Customer Safety Information (CSI) for Field Safety Corrective Action:

AX028/20/S

Subject: Customer Safety Information concerning the repair of the x-ray generator Polydoros M25 revision 04 which is included in certain Cios Spin & Cios Alpha systems.

figure 1: example of monitor trolley connected to the XIO connector of the main unit (c-arm) by main cable

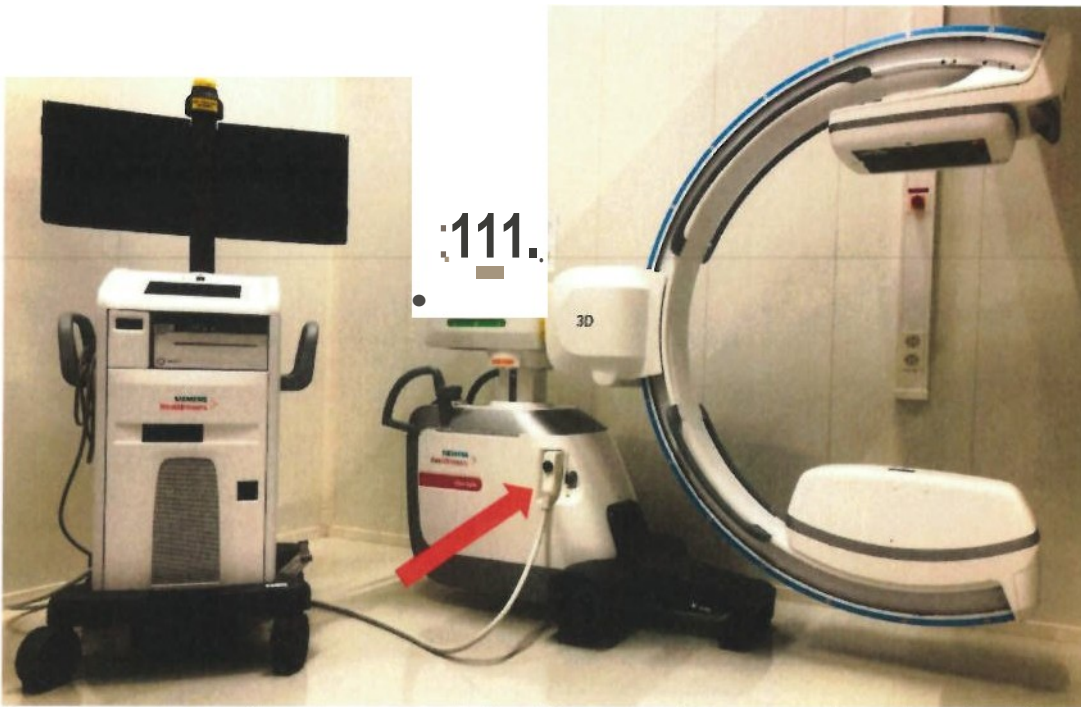
During the operation of the Cios system the monitor trolley of the Cios system is electrically connected with the main unit (c-arm) of the Cios System by a main cable. The main cable can be plugged or unplugged from the XIO connector which is part of the main unit (c-arm) at any time during clinical session (see figure 1 and 2). The unplugging of the main cable can cause an unsafe electrical voltage (up to 67,6 V DC) at the XIO connector which can result in an electrical shock if the user or other persons touch the contact pins of the XIO connector. These contact pins of the XIO connector are accessible when the main cable is unplugged from the XIO connector (see figure 2 and 3).

There is no impact to the operation of the system but there is a danger to health of the user or other persons due to the above described risk of an electrical shock when the main cable is unplugged and the user or other persons touch the contact pins of the XIO connector.

The problem was identified by the manufacturer during system assembly when the plug of the main cable was unplugged. The root cause is a design flaw in a generator component of the generator Polydoros M25 revision 04.

We strongly recommend to not unplug the main cable until the generator is repaired by a service engineer.

A service engineer will repair the generator of your affected system at your site.

After repair of the generator the root cause which led to the unsafe electrical voltage at the XIO connector will be eliminated.
